Request for Reconsideration:

Remarks:

FIG. 4

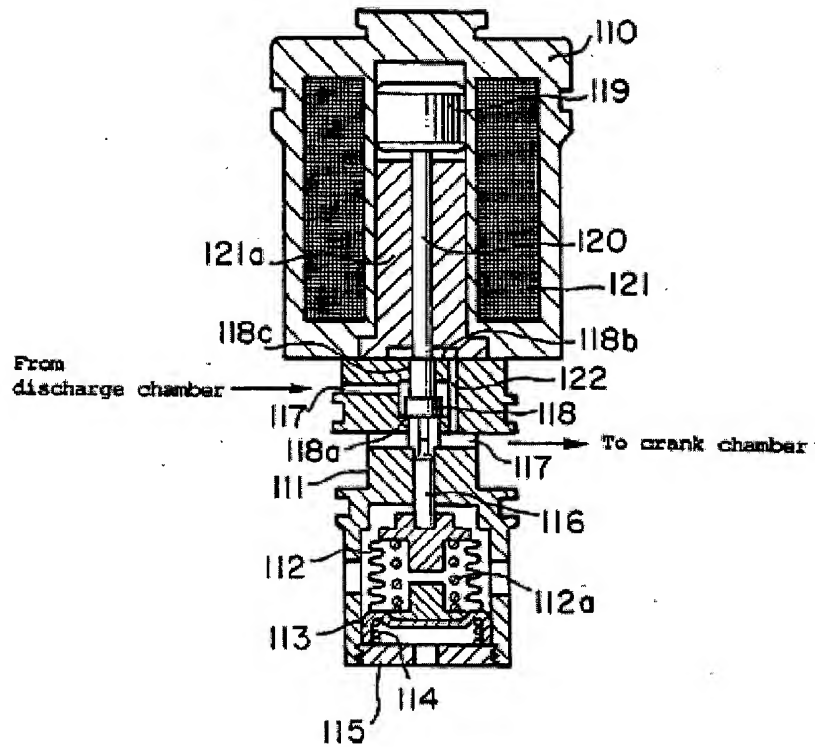
RELATED ART *add legend*

The Office Action objects to the drawings because **Fig. 4** allegedly illustrates known displacement control valve, but is not designated by a legend, such as “Prior Art.” MPEP 608.02(g). Thus, Applicant is amending **Fig. 4** by adding the legend “Related Art.” Therefore, Applicant respectfully requests that the Examiner withdraw the objection to the drawings.
